TECHNICAL NOTE

**TRUE ADVANCED PURGE™ MODEL TAP-G3
RECENT ISSUES AND RESOLUTIONS**

As part of our program of continuous improvement, **UNITED Fire Systems** has implemented improvements to the **TRUE ADVANCED PURGE™ Model TAP-G3** device in response to several issues.

**Model TAP-G3 Display Screen
Shown In ACTIVE DRIFT CONTROL™ Mode**

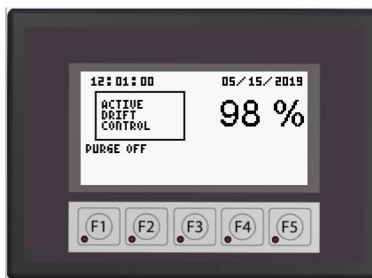
Issue – During the nightly automatic drift control (ADC™) procedure, users monitoring the **Model TAP-G3** fault contacts with a BMS or fire alarm system were receiving fault signals considered a nuisance when there was no actual fault.

Resolution – **UNITED Fire Systems** has updated the **Model TAP-G3** firmware to disable operation of fault contacts K1 and K2 during ADC™. Normal operation of the contacts is re-enabled after the automatic procedure is complete. The following table appears in Manual P/N 33-TG3MAN-000 Revision 1.01 on Page 9.

Model TAP-G3 devices manufactured on and after 11 Mar 2024 will be factory-programmed with this updated firmware. Devices manufactured before that date can be field-updated by **UNITED Fire Systems** for users requiring this feature. Contact **UNITED Fire Systems** for service.

**MODEL TAP-G3
INLET PORT**

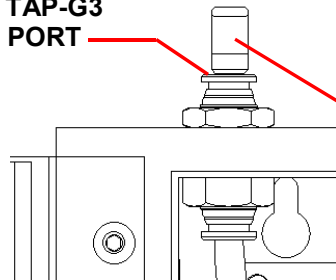
Issue – Installers have observed on occasion that debris has entered the sensor chamber of some **Model TAP-G3** devices. **UNITED Fire Systems** believes such debris entered the devices during installation. While the debris at this time has not resulted in inaccurate nitrogen purity readings or premature sensor failure, **UNITED Fire Systems** believes the entry of debris should be prevented.

Resolution 1 – To avoid debris entry directly into the **Model TAP-G3** inlet port, **UNITED Fire Systems** now installs a plug into the port at the time of assembly.

Keep the factory-installed plug in the port throughout and after the installation process. Remove the plug only immediately before attaching the sampling tubing to the port. Discard the plug after removal.

**PLUG – REMOVE JUST PRIOR TO
ATTACHMENT OF TUBING**

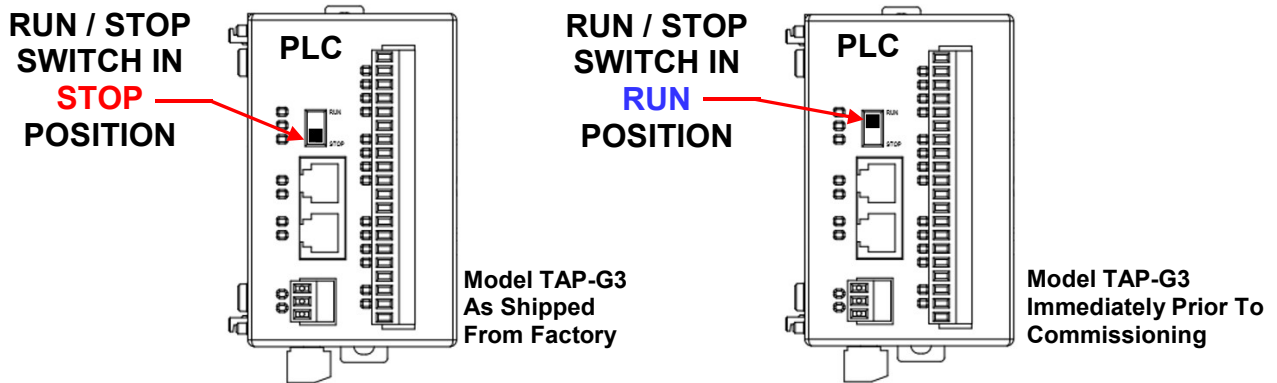
Issue – Several users have observed that their **Model TAP-G3** HMI (Human-Machine Interface) screen has turned a pinkish hue. **UNITED Fire Systems** has determined that this phenomenon occurs when the **RED** flashing of the screen during a fault has been allowed to continue for a very extended period of time.

Resolution 1 – Up to now, connecting live 115 VAC power to the **Model TAP-G3** device far in advance of commissioning has resulted in **RED** flashing for a long period. To prevent this flashing, **UNITED Fire Systems** is now leaving the PLC (Programmable Logic Controller) in **STOP** mode after factory testing.

Place the PLC **RUN / STOP** switch into the **RUN** position ONLY immediately prior to commissioning.
